# Access Compliance Report

## Public Rights-of-Way

Intersection ID: 11764	Main Street: BEACON_ST	Cross Street: MECKLENBURG_AV	Location: NW
ADA ID: 5EBADECCE46C	Ramp Type: Perp	Initial Pass/Fail: Fail	Overall Compliance: No
Severity Score: 35			
Codes/Mitigation Info/Possible Solution		Field Measurements/Component Compliance

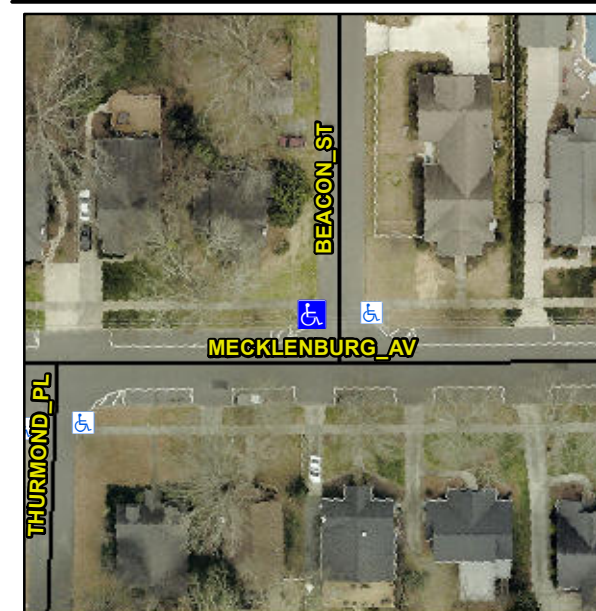
**Not Found, R304.5.1**

Compliance	Description	Data	Compliance	Description	Data
N/A	Ramp Length (in)	61.0	Yes	Ramp Slope (%)	7.8
No	Ramp Width (in)	30.0	Yes	Ramp XSlope (%)	2.0
N/A	Flare Type LT	N/A	N/A	Flare Type RT	N/A
N/A	Flare Slope LT (%)	N/A	N/A	Flare Slope RT (%)	N/A
N/A	Flare Traversable LT?	N/A	N/A	Flare Traversable RT?	N/A
N/A	Landing Length (in)	N/A	N/A	DWS Provided?	N/A
N/A	Landing Width (in)	N/A	N/A	DWS Contrast?	N/A
N/A	Landing Slope (%)	N/A	N/A	DWS Length (in)	N/A
N/A	Landing X Slope (%)	N/A	N/A	DWS Full Width?	N/A
N/A	Landing Curb? (Y/N)	N/A	N/A	DWS Offset (in)	N/A
N/A	Shared Landing?	N/A			
N/A	Gutter Ponding?	N/A	N/A	Gutter Slope (%)	N/A
N/A	Gutter Lip Ht (in)	0.5	N/A	Gutter X Slope (%)	N/A
N/A	Painted X Walk1?	No	N/A	Painted X Walk2?	N/A
	X Walk 1 Direction	To E		X Walk 2 Direction	N/A
N/A	X Walk 1 Width (in)	N/A	N/A	X Walk 2 Width (in)	N/A
	X Walk 1 Slope (%)	2.7		X Walk 2 Slope (%)	N/A
	X Walk 1 X Slope (%)	2.9		X Walk 2 X Slope (%)	N/A

**Remove & Replace Entire Ramp.**
